2275MUX/MUXE DISK MULTIPLEXER

ECO NO. 47057

PART NO.	210-8824	DESCRIPTION	2275 MUX MASTER
DWG NO.	8824	PEP #	PEP# HU
MODEL NO.	2275 MUX	PEP #	
CLASS	I (11) III		PRIMARY

ECO NO. 525.2
SHEET 1 OF 6

8824-2 COMPONENT SIDE

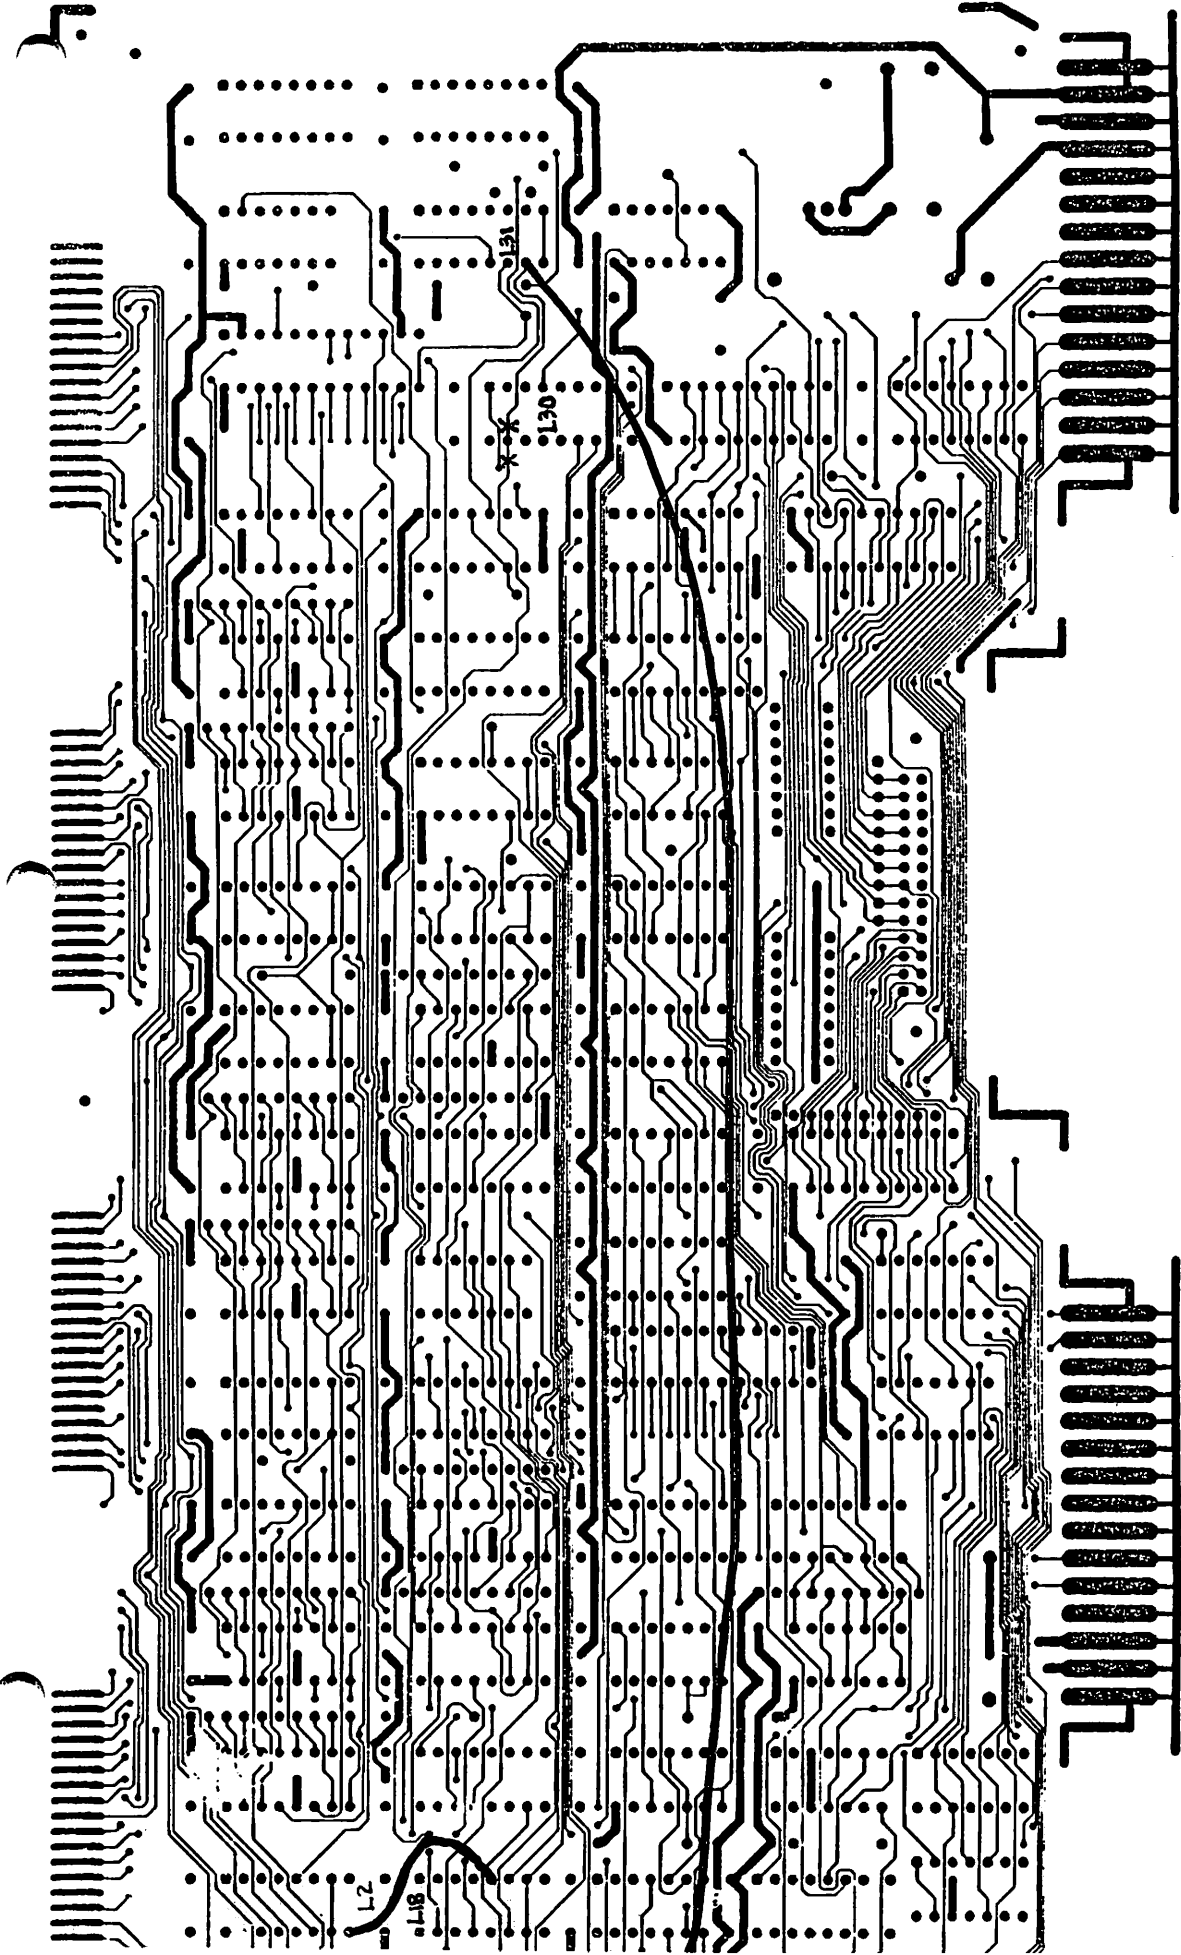
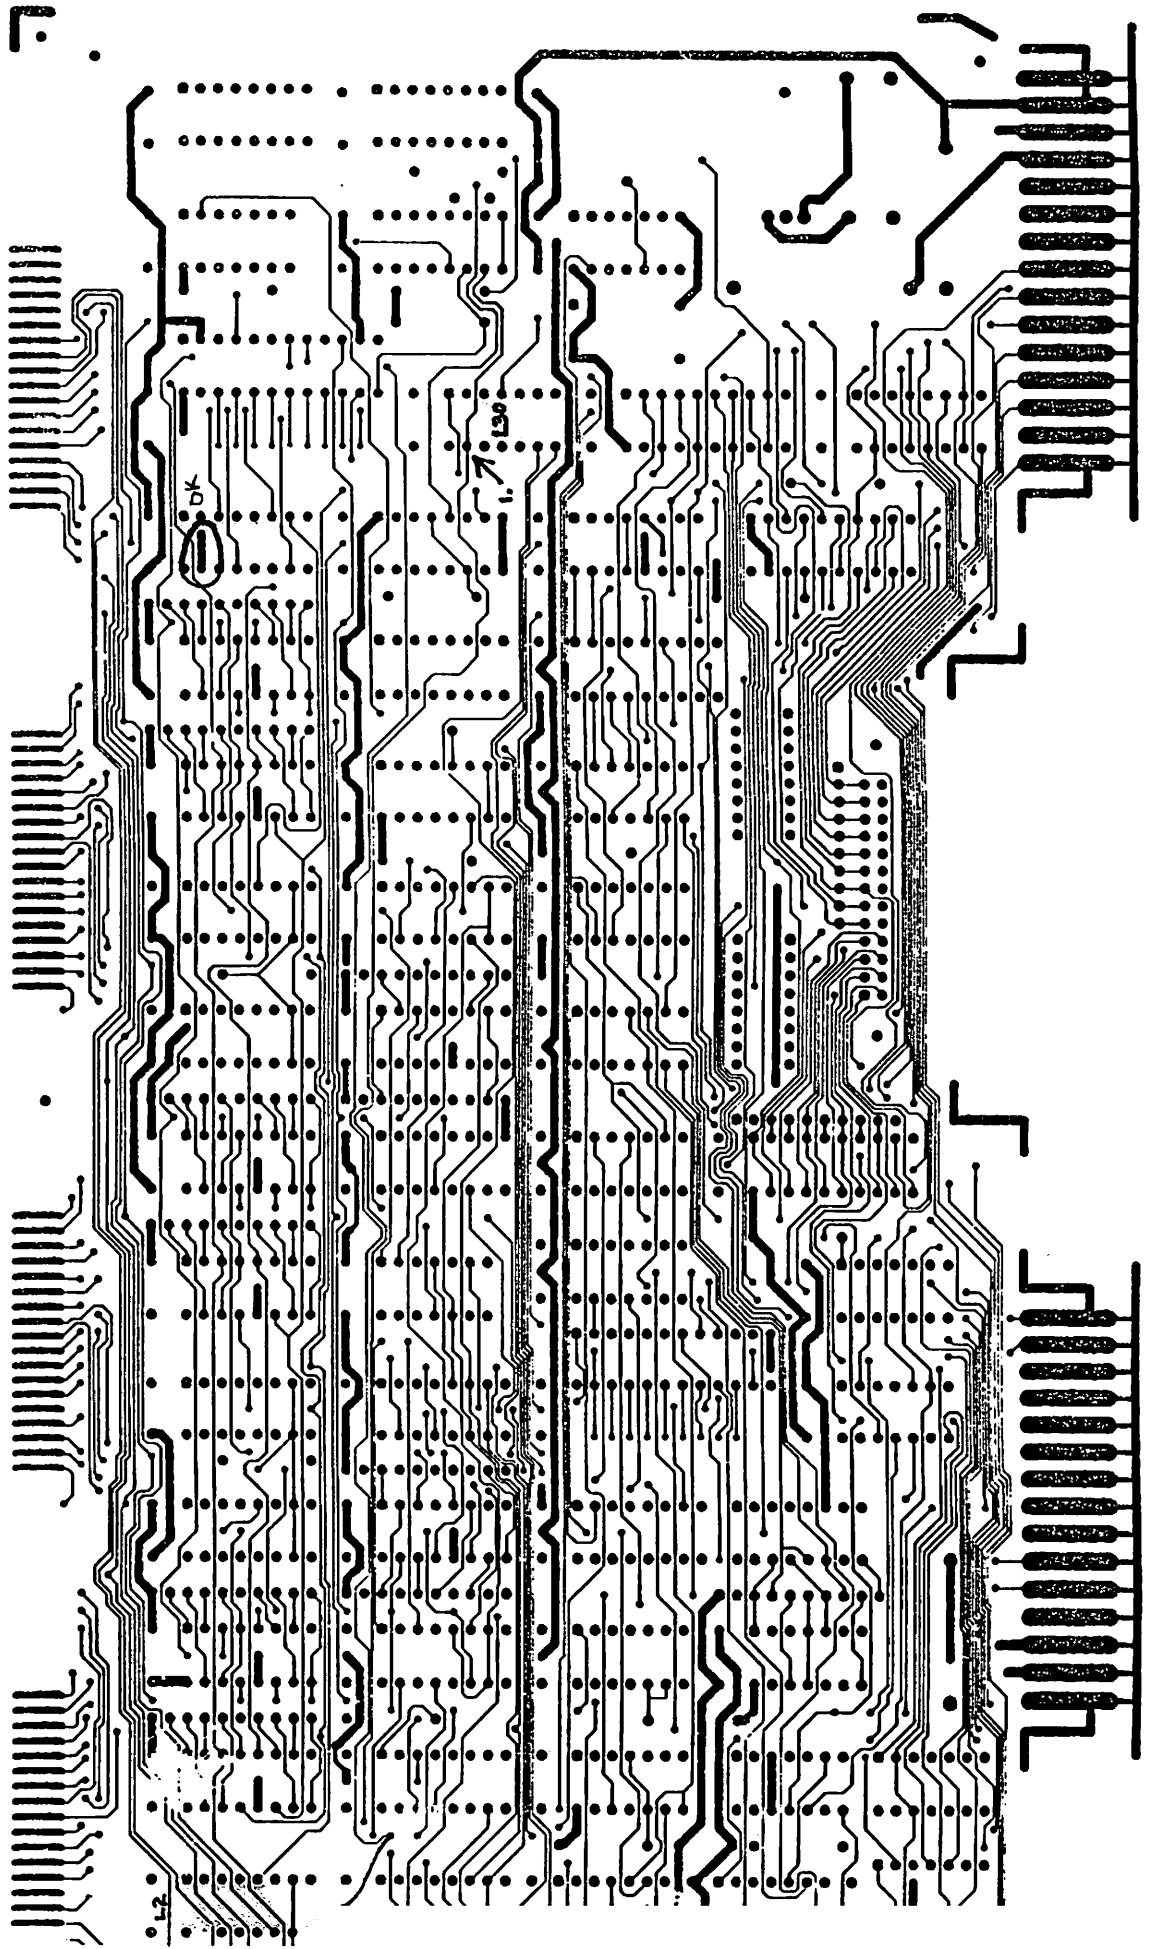
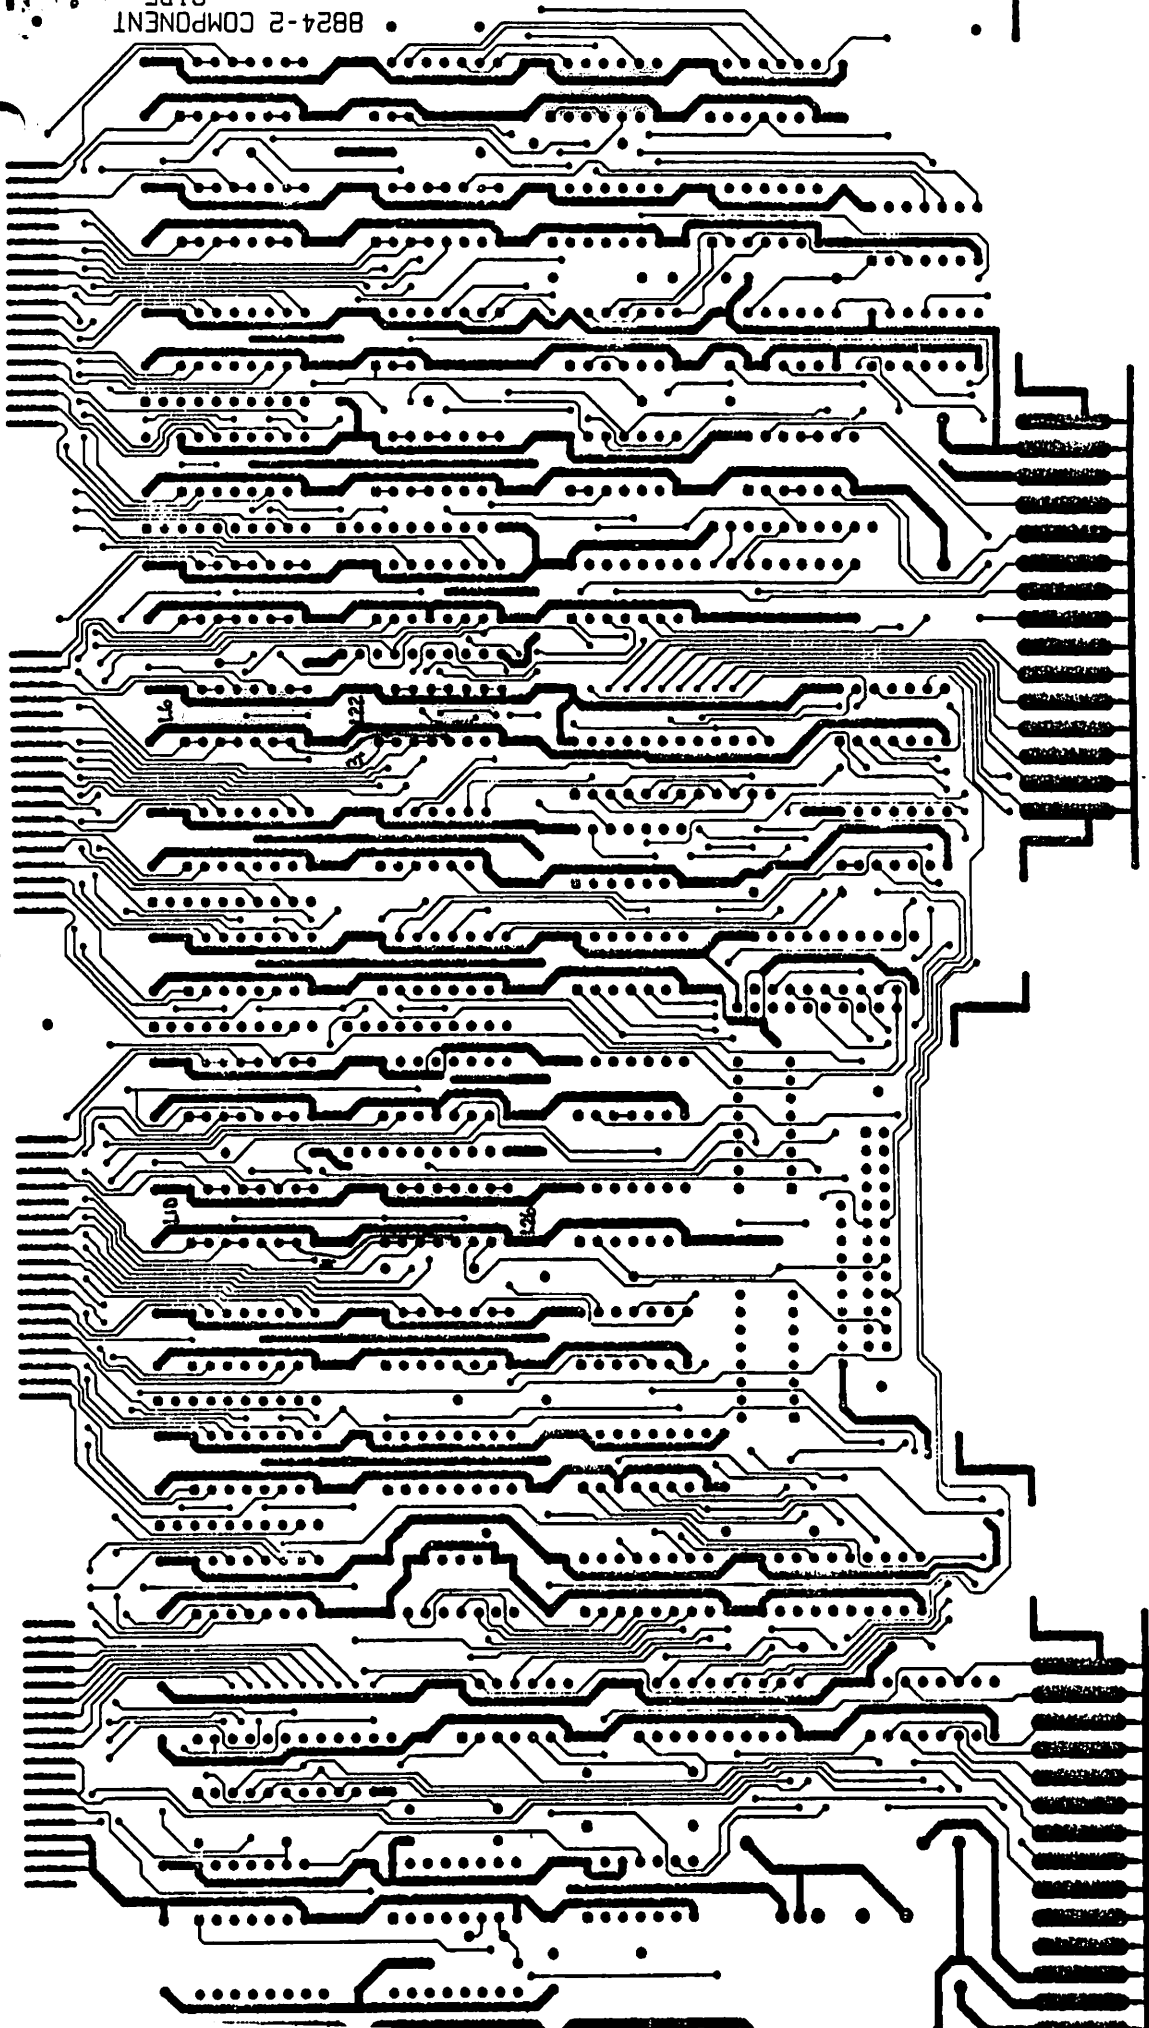
1. ETCH FROM L31 PIN 10 TO L33 PIN 5 IS CONNECTED TO L30 PIN 13
 L30 PIN 13 MUST BE ISOLATED.
2. TIE FEEDTHRU FOR TOP OF R1 OR L2 PIN 6,7,9, OR 10 TO (L30 PIN 2
 L18 PIN 5)
3. TIE FEEDTHRU FOR (TOP OF R4 OR L6 PIN 10,9,7,6) TO (L23 PIN 4 OR L22 PIN 5)
4. TIE FEEDTHRU FOR TOP OF R7 OR L10 PIN 6,7,9,10 TO (L23 PIN 2 OR L26 PINS)
5. Fix SCHEMATIC SHEET 3 OF 3 (3 C12), ~~L30 PIN 2~~
 L18 PIN 7,9,10,11 + L22 PIN 7,9,10,11 SHOWN CONNECTED TO L2 PIN 6,7,9,10 &
 L1 PIN 6,7,9,10
 SHOULD MAKE TIE PT TO L30 PIN 2 + L18 PIN 5
5. ERASE ECU 48499 SCHEMATIC. CUT #2 IN WRONG PLACE.

2. L13 PIN 15 TIED TO GROUND ON 8824-2 ?

TIED TO L47 PIN 8

- Rework Artwork 2 Board as follows:
 On circuit side cut etch to L30 Pin 13 on both sides of Pin 13.
 Add wire from L31 Pin 10 to L33 Pin 5.
 On circuit side add wire from L2 Pin 9 to L18 Pin 5.
 On component side add wire from L6 Pin 7 to L22 Pin 5.
 On component side add wire from L10 Pin 7 to L26 Pin 5.
- Make following correction to schematic, sheet 3 of 3, loc C12:
 Line from L2 Pin 10 (3I2) should tie to line between L30 Pin 2 and L18 Pin 5 (3C12). It should not connect to L18 Pin 7 (3C12).

TITLE MUX N.

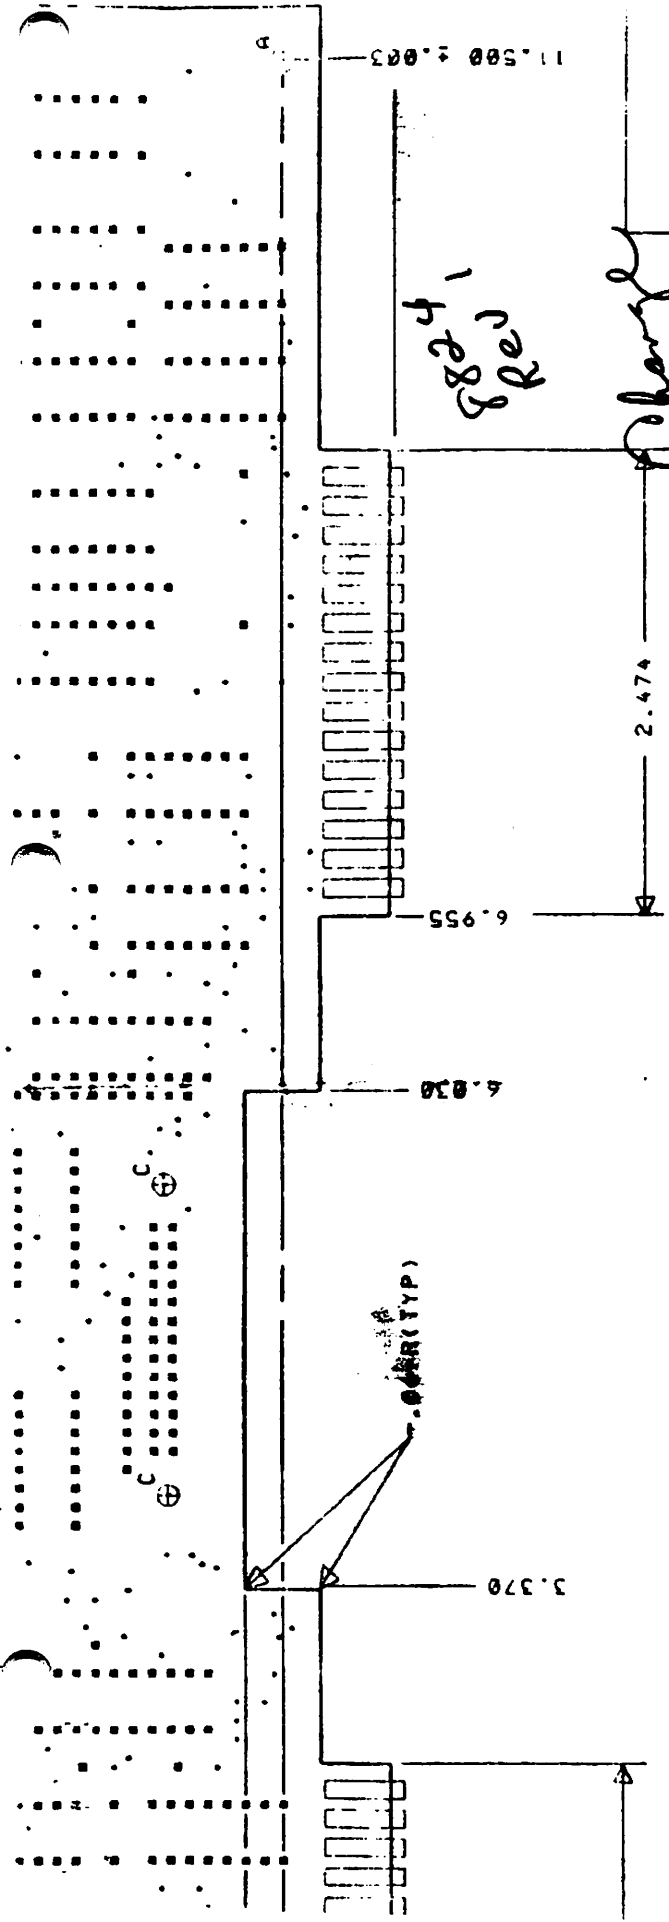
Change note 3 on Fab drawing per attached.

1. Remove etch on circuit side between L30 pin 13 and L31 pin 10.
2. Remove etch on component side leading to L33 pin 5.
3. Add etch from L31 pin 10 to L33 pin 5.
4. Tie feedthru for top of R1 to L18 pin 5.
5. Tie feedthru for top of R4 to L23 pin 4.
6. Tie feedthru for top of R7 to L23 pin 2.
